# **Plastic Pipe Rule**

**(RIN 2137-AE93)**

**Docket: PHMSA-2014-0098**

**June 1, 2016**

# A. Tracking and Traceability: Example fitting with numeric code and 2 barcode varieties

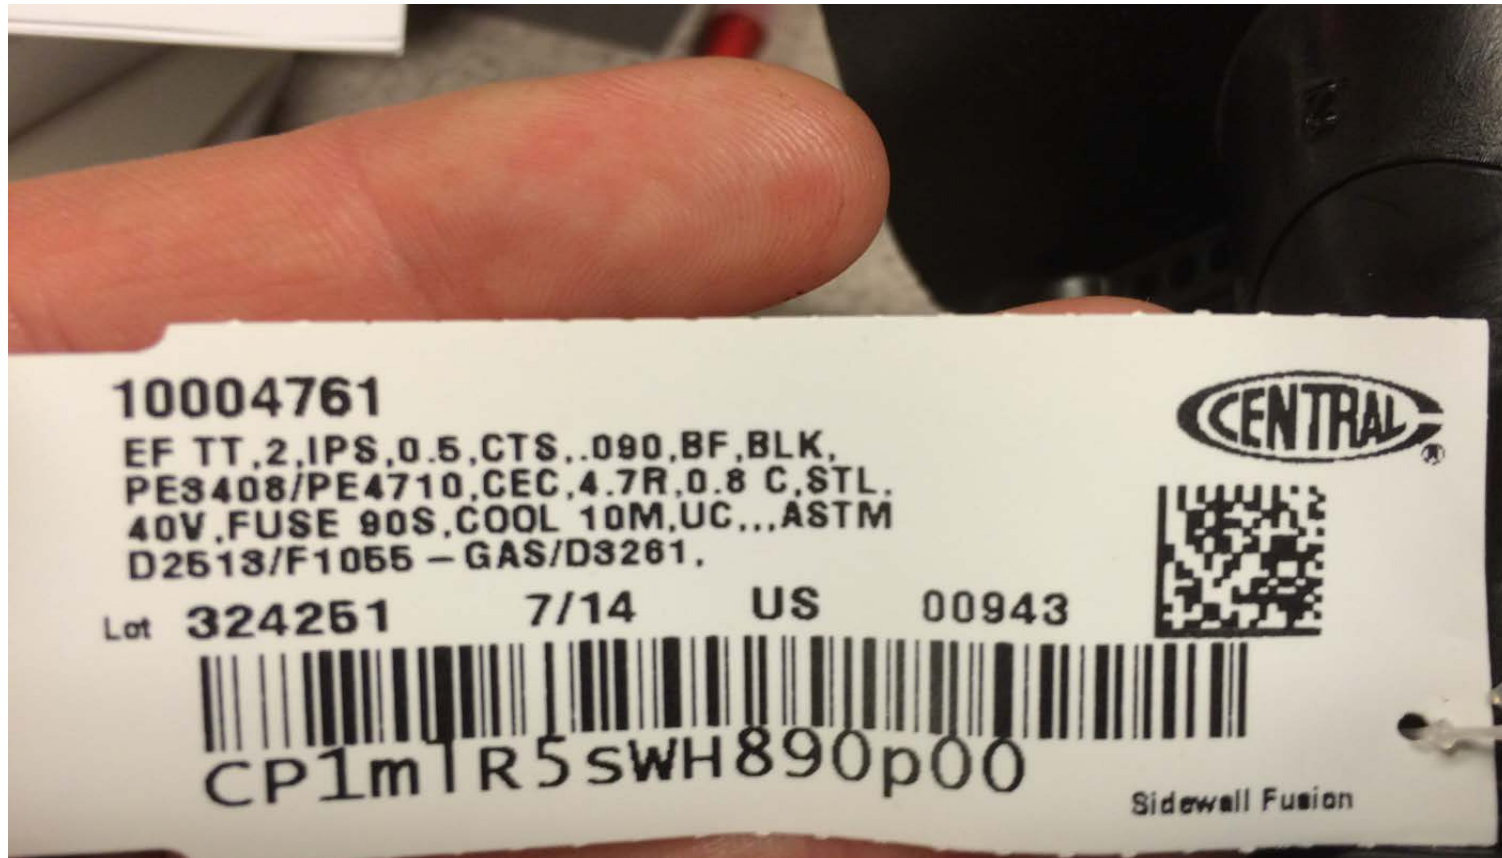
- **Laser**
  - Still being investigated for pipe applications
  - Small footprint
  - Won't rub off
  - Capital intensive (2-3x's ink jet)
- **UV Cured Inks**
  - Adds a process step
  - Adhesion can be an issue
  - Faster drying times
